CITY OF OPELIKA HISTORIC PRESERVATION COMMISSION

March 13, 2025

HISTORIC PRESERVATION COMMISSION MINUTES

City of Opelika
Historic Preservation Commission
Staff Report

Photo's:

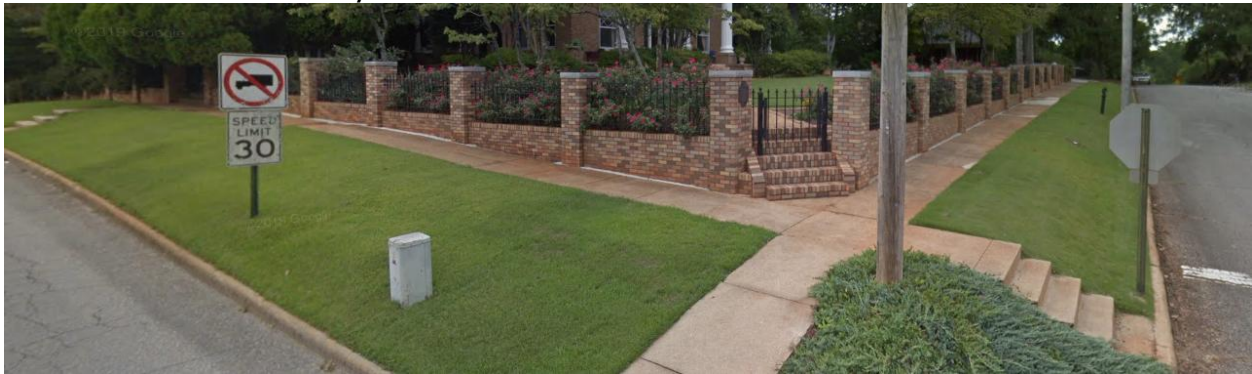
1. Remove existing brick walls at curb and behind sidewalk and grade to match neighboring properties. The walls are falling in several areas. A new sidewalk will be poured and grass installed.

Damaged/failing wall

Damaged/failing wall

New drive installed for access to twin homes and future development (steps removed)

1. Staff recommend approval of removing both brick walls, grading, and sodding so landscape will be consistent with adjoining properties.
